**STATE SIGNIFICANT DEVELOPMENT
ASSESSMENT REPORT:**

***Redevelopment of the Australian
Technology Park, Eveleigh***

SSD 7317

Environmental Assessment Report
Section 89H of the *Environmental Planning and
Assessment Act 1979*

Figure 10: Typical commercial floor plan of Building 1 showing atria in orange (Source: applicant's RTS)

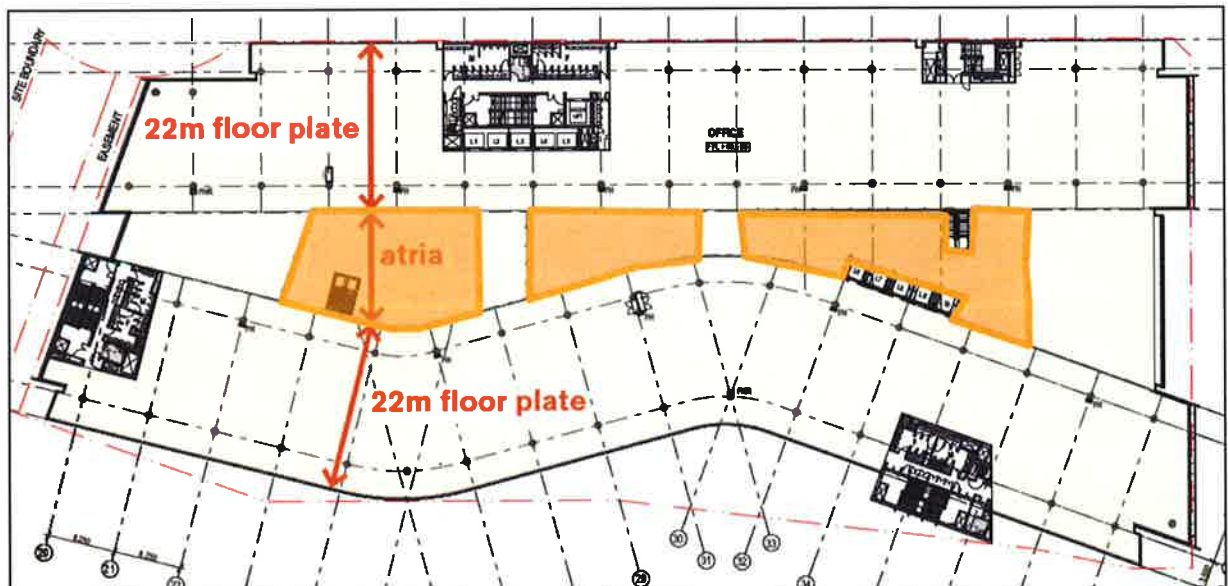
- three levels of above ground car parking; and
- the series of internal atria (**Figure 10**).

Figure 15: Overshadowing of the Alexandria Child Care Centre (Source: applicant's RTS)

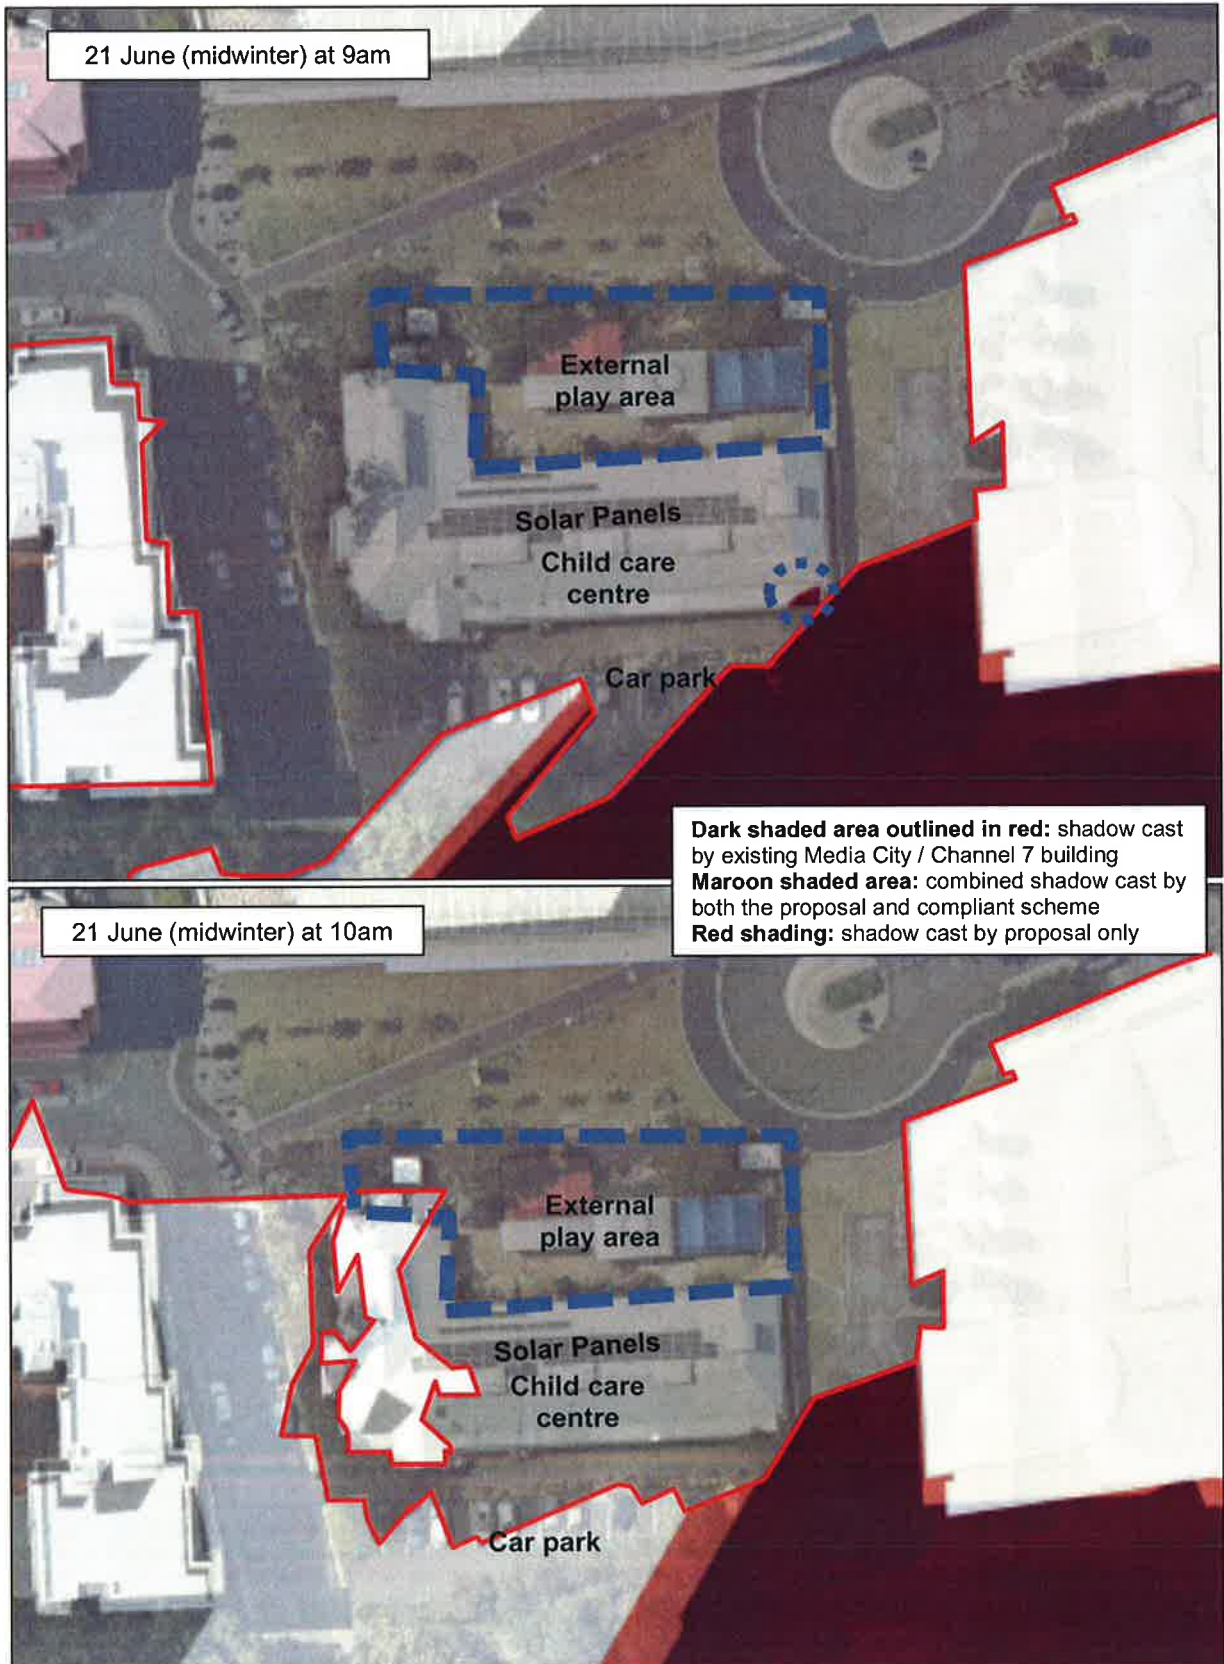
In addition to any overshadowing caused by the existing Media City / Channel 7 building to the north, the proposed scheme and a GFA / height compliant scheme will overshadow approximately 4m² of the south east corner of the child care centre roof between 9am and 10am in midwinter (being the worst case scenario) (**Figure 15**). The Department is satisfied this overshadowing will impact only a small area of the roof (and is clear of the solar panels mounted on the roof), will not impact on the amenity of the centre and its external play area and the shadow will last until 10am in midwinter.

The Department also notes the proposed scheme will overshadow an area of the car park to the south of the child care centre building (**Figure 15**). However, this overshadowing will not impact on the amenity of the centre or its external play area, and will pass by 11am in midwinter.

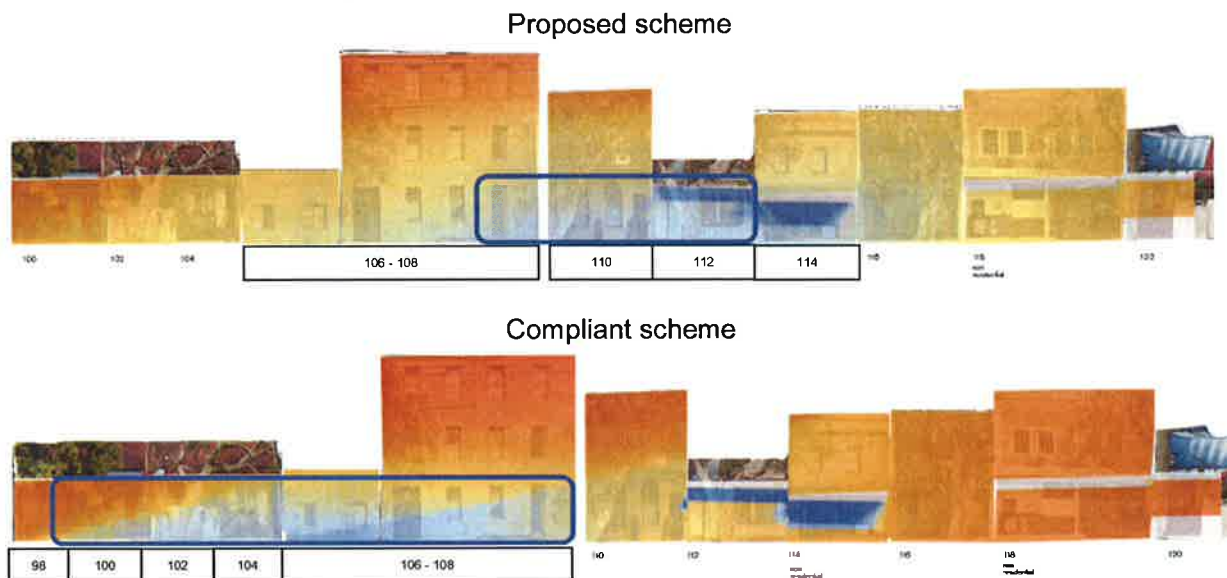
The applicant's analysis shows that parts of three residential properties to the south of Henderson Road (namely Nos. 106-108, 110 and 112) will not achieve this as a result of the proposal, compared to five properties as a result of a height and GFA compliant scheme (namely Nos. 98, 100, 102, 104 and 106-108) (**Figure 17**). The applicant's analysis also shows that all skylights will receive at least two hours of direct sunlight between 9am and 3pm in midwinter.

The Department has carefully considered the applicant's sunlight analysis against the requirements of the DCP. While it shows the proposal will not result in additional overshadowing impacts beyond that of a compliant scheme, the Department notes that, in addition to including the maximum allowable height and GFA, the compliant scheme used for the modelling includes several design features that enhance bulk and height to the building and subsequently result in additional overshadowing impacts. These include:

Figure 18: Concept diagrams showing area of Building 1 to be removed in blue (Source: applicant's additional information)

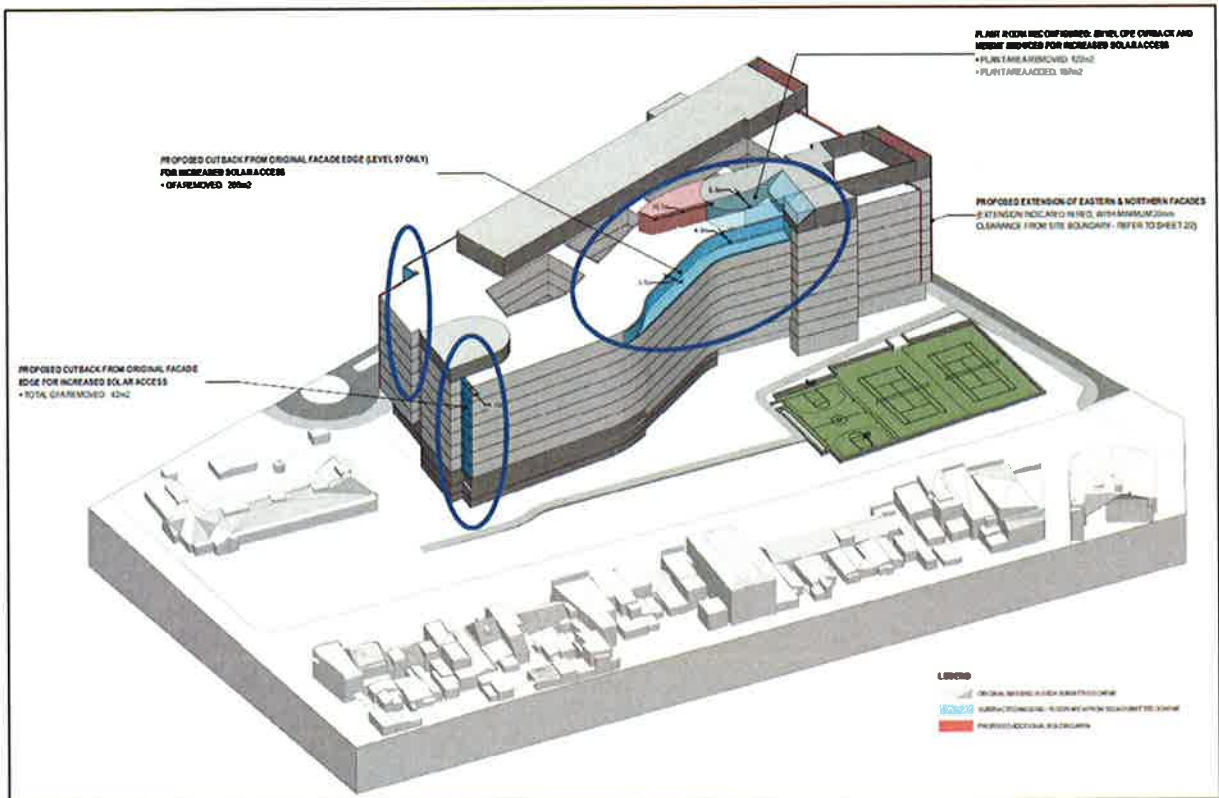
The Department therefore does not accept this analysis is sufficiently robust to provide justification for significant overshadowing impacts associated with the proposed exceedance of the height and GFA controls for the site.

Subsequently to forming this view, the Department requested the applicant amend Building 1 so that all residential properties to the south of Henderson receive at least two hours of direct sunlight between 9am and 3pm in midwinter. The applicant has provided concept diagrams and an updated shadow analysis showing the extent of amendments to Building 1 to achieve this requirement. These amendments include (as shown in blue on **Figure 18**):

- removal of 206m² GFA from the southern elevation at Level 7;
- removal of 53m² GFA from the northern and southern corner at Levels 1 to 7; and
- reconfiguration and removal of 15m² of the rooftop plant.

The applicant will need to amend the architectural drawings for Building 1 to reflect in detail the revised built form demonstrated in the concept diagrams (**Figure 18** and **19**), so that all properties to the south of Henderson Road receive at least two hours of direct sunlight between 9am and 3pm in midwinter. This is required through a recommended condition.

Figure 19: Concept diagrams showing area of Building 1 to be expanded in red (Source: applicant's additional information)

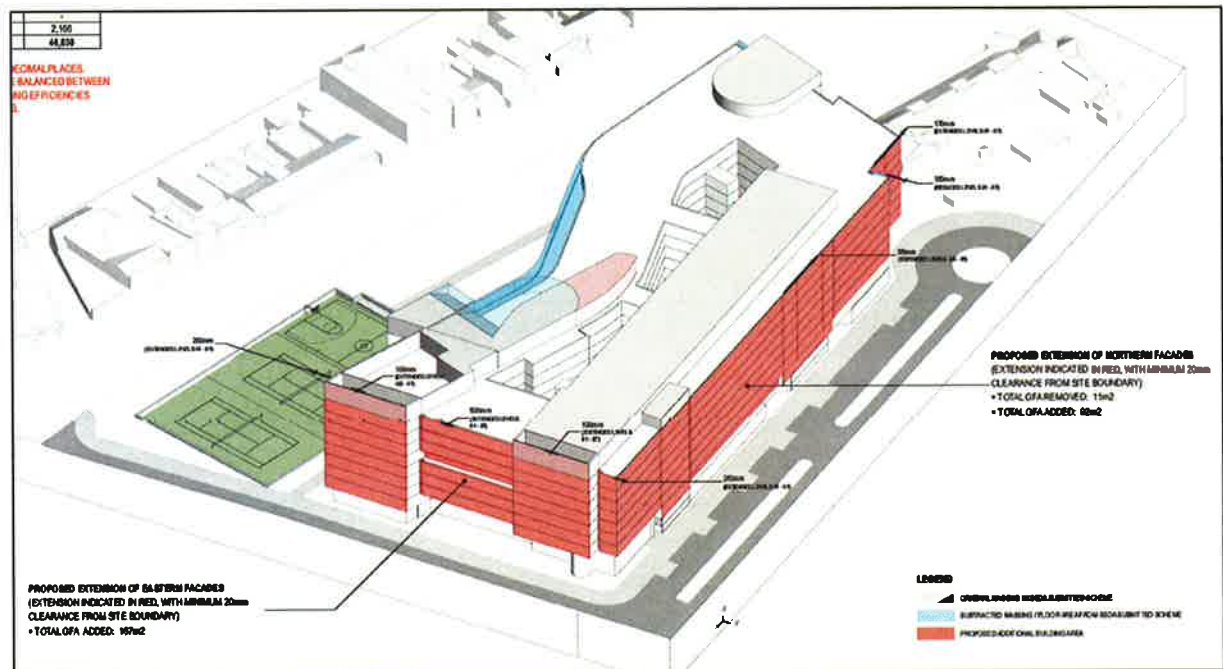
The applicant notes that the built form of Building 1 can accommodate the removed GFA (of 259m²) by extending the building floorplate by between 55mm and 500mm to the north and east (Figure 19), while ensuring that the residential properties to the south of Henderson Road continue to receive at least two hours of direct sunlight between 9am and 3pm in midwinter (Figure 20).

Figure 20: Properties to the south of Henderson Road to receive at least two hours of direct sunlight between 9am and 3pm in midwinter (shown in yellow and orange) and less than two hours shown in blue as a result of the amendments (Source: applicant's concept diagrams).

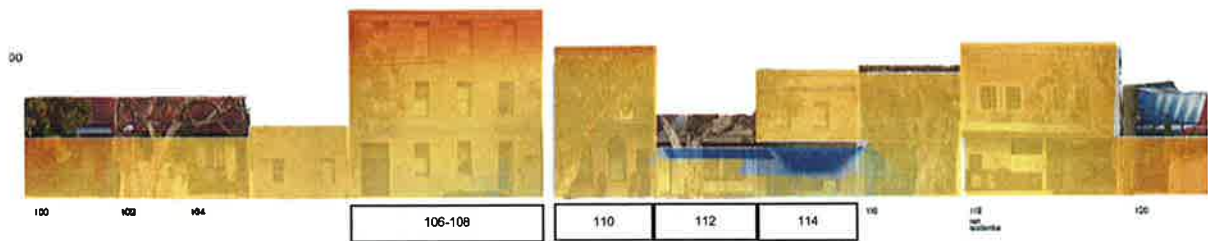
The Department has reviewed the applicant's concept diagrams and updated shadow analysis and is satisfied that:

Figure 21: Proposed activation of the public domain at ground level (Source: applicant's RTS)

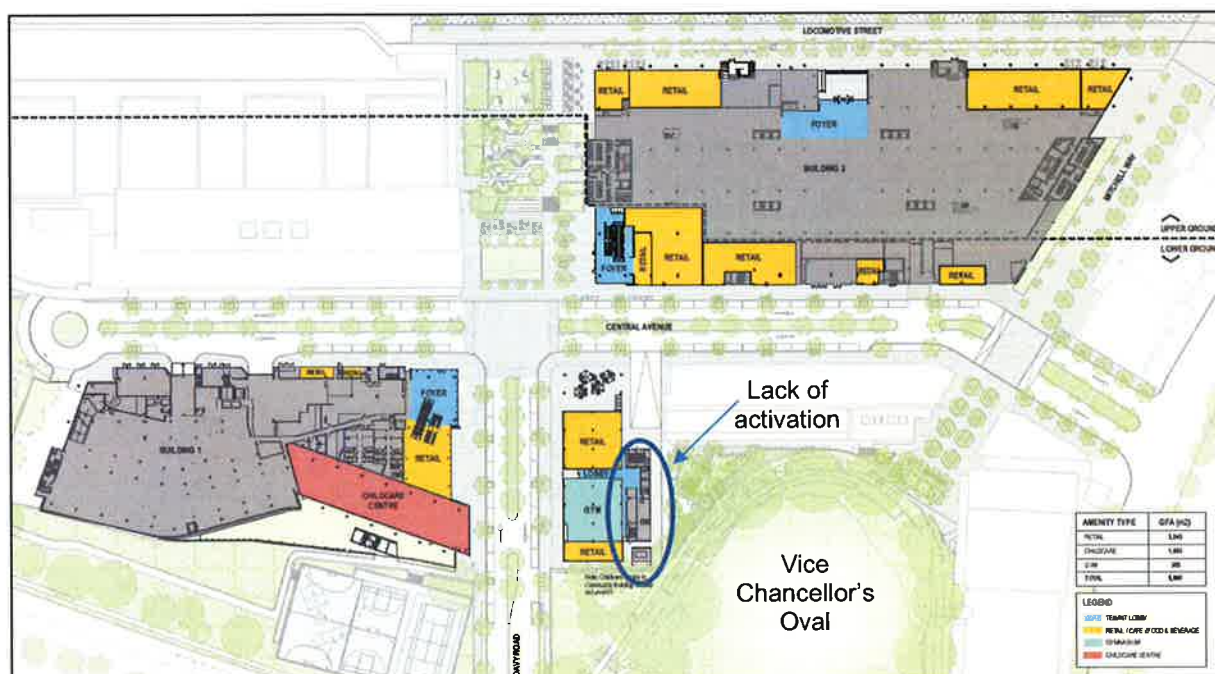
The Department shares Council's concerns that the predominantly solid façade of the stair / lift core to the east of Building 3, together with the proposed substation to the south east of the building, will not sufficiently activate the public domain in the north western corner of the Vice Chancellor's Oval (**Figure 21**). This is particularly important as the building in this location presents genuine urban design opportunities to provide improved activation of the public domain.

The Department notes the proposed child care facility on Level 1 provides some limited activation to the adjacent public domain. In the RTS, the applicant has replaced some gym floor space on the ground floor to the south of Building 3 with retail, however this does not increase activation to the public domain to the east of the building (**Figure 21**). The Department therefore considers that further design amendments are required to increase activation and improve the amenity of the public domain. A condition is therefore recommended requiring the removal or relocation of the proposed substation and design amendments to increase activation of the south east corner of Building 3.

The Department is satisfied that, subject to the recommended conditions, the form and external appearance of the three buildings will enhance the quality and amenity of the public domain.

Figure 23: Major pedestrian routes into and through the ATP during the AM Peak (Source: Applicant's Additional Clarification)

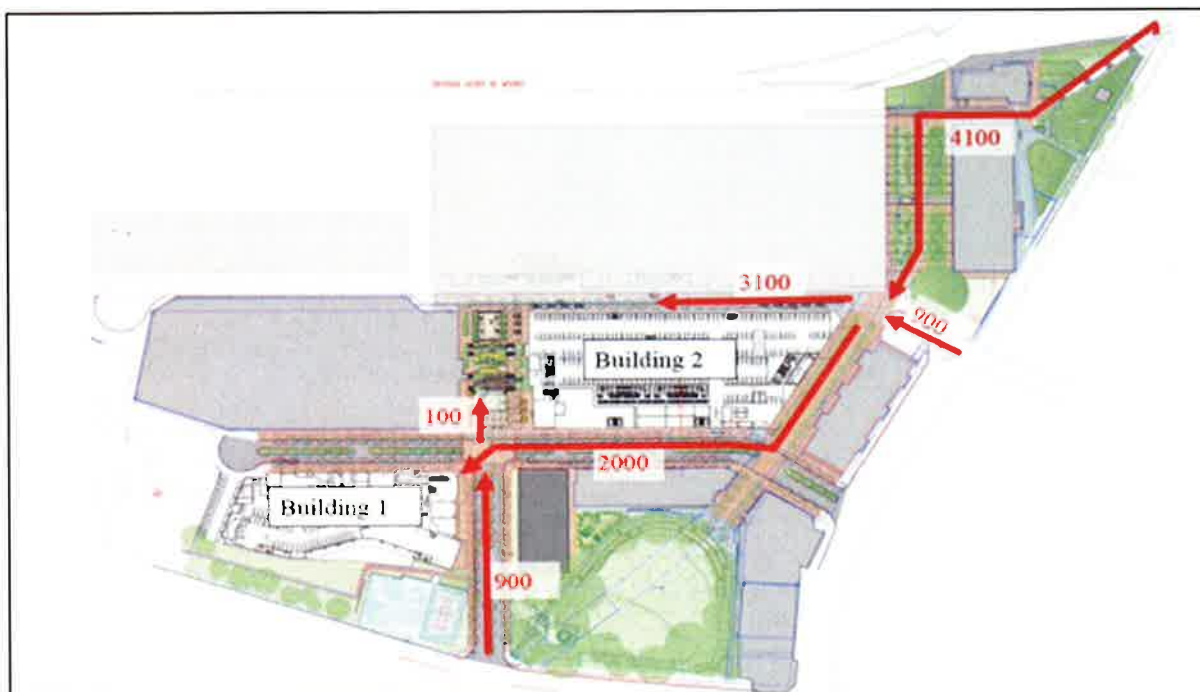
Figure 23 shows the busiest pedestrian links are anticipated to be those that connect to Redfern Station with approximately 4,100 people arriving in the AM peak hour. Based on the predicted number of pedestrians and their preferred pedestrian pathways, the majority of pedestrians are anticipated to use existing pedestrian movement corridors, allowing free pedestrian movement through the site without pedestrian conflicts and delays.

The Department notes Council's suggestion for a further pedestrian crossing half way up Davy Road to connect pedestrian connections to the south of Building 1 and Building 3. However, the Department considers the existing pedestrian crossings at the junction of Henderson Road / Davy Road and Central Avenue / Davy Road provide suitable pedestrian crossing opportunities and are more desirable for pedestrians entering the ATP from the south and west.

Figure 25: Car park and loading dock entry points for Building 1 (top) and Building 2 (bottom), with the area requiring reconfiguration shown in blue (Base source: Applicant's Rts)

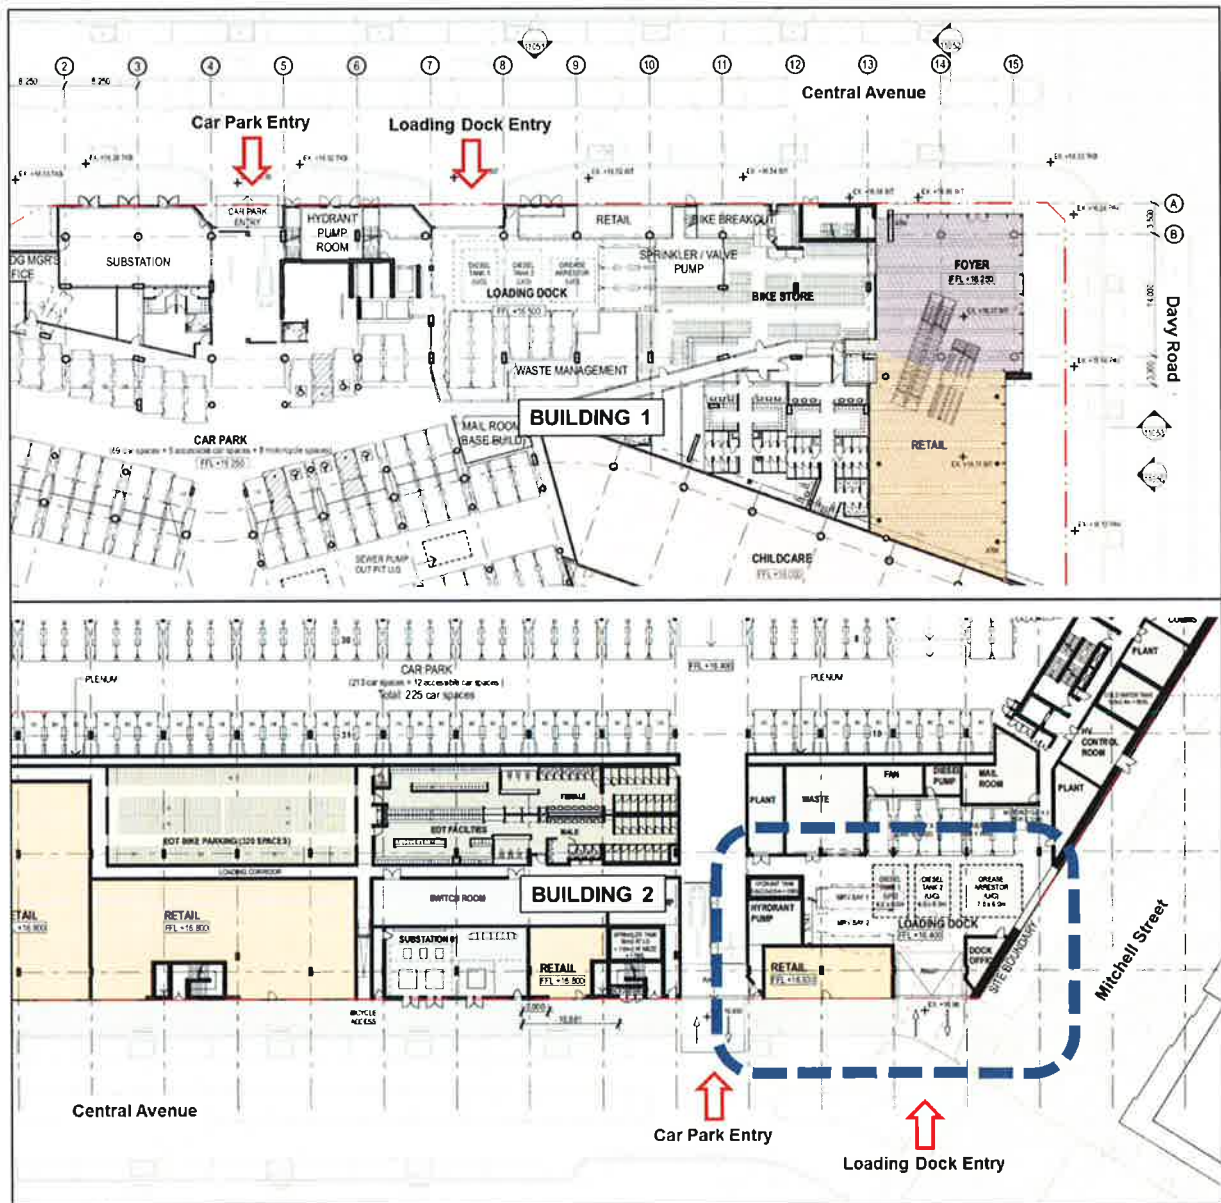
Council has raised concern that the multiple driveways for each building have a negative impact on pedestrian amenity and safety and recommends that each building's car parking and loading dock be accessed via a single vehicular access.

The Department notes the two vehicular entrances for Building 1 are separated by approximately 18m, located away from the intersections and provide clear sightlines for access and egress. The

In addition, there is no right hand turn available into the loading dock from Central Avenue due to a proposed road island and plantings located opposite the entry. This will cause large vehicles entering from Garden Street to the east to traverse along Central Avenue, past another key pedestrian intersection at Davy Road/Central Avenue to access the roundabout and enter the loading dock from a left hand turn. To ensure appropriate sight lines at key intersections, reduce vehicular movements through the site and to ensure pedestrian safety the Department considers the car parking and loading dock entrances for Building 2 should be consolidated into one vehicle access ramp located away from the Central Avenue / Mitchell Road intersection. The Department notes this may result in some minor reconfiguration of the internal plant (hydrant pump and tank) and that the retail unit on the south eastern corner of the building may in the future be enlarged to wrap around and activate this corner of the building.

The Department recommends a condition requiring the car park and loading dock entrances for Building 2 be combined and appropriately designed driveway crossovers be implemented. The Department also recommends a condition requiring a loading dock management plan to ensure the safe operation of the loading dock when integrated with the vehicular access.
